ADDENDUM #3

To: RFQ# 1111-909-62-3654
RFQ for Repairs at 1004 Alametos
Date: December 13, 2011

MOLD LOCATION DRAWING

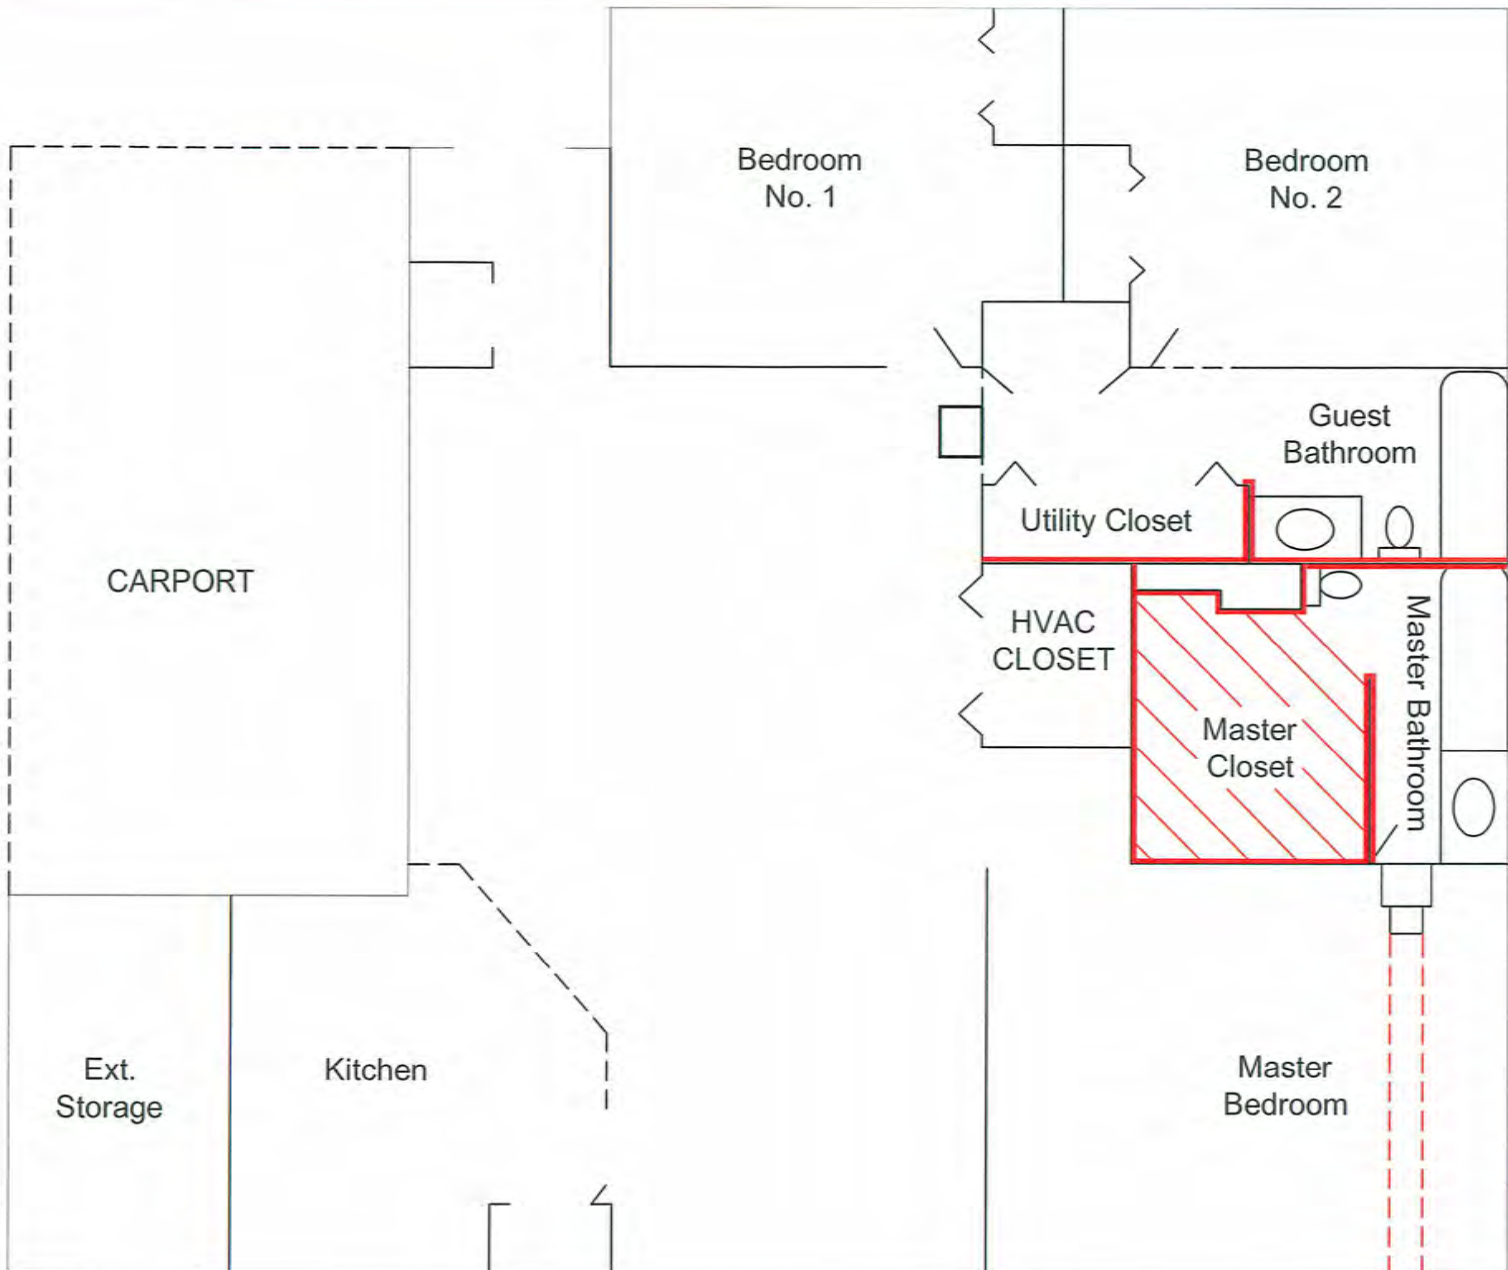
Question 1: My estimator needs measurements for the countertop Formica repair, the damaged sheetrock that was abated for mold and for the new insulations where it was removed for abatement. He also needed measurements for the size of the water damage penetration or leak above the master closet that needs repair. We need not find any of this information in the inspection report.

Answer 1: The Formica repair is an end cap on one side of the counter, about two feet long. Approximately 525 sqft of mold impacted drywall was removed. Attached is a drawing which redlines what was removed. As for the water leak above the master closet, we are not sure where it is coming from. There is no obvious location, but there was a water stain on the ceiling where the master closet sheetrock was removed.
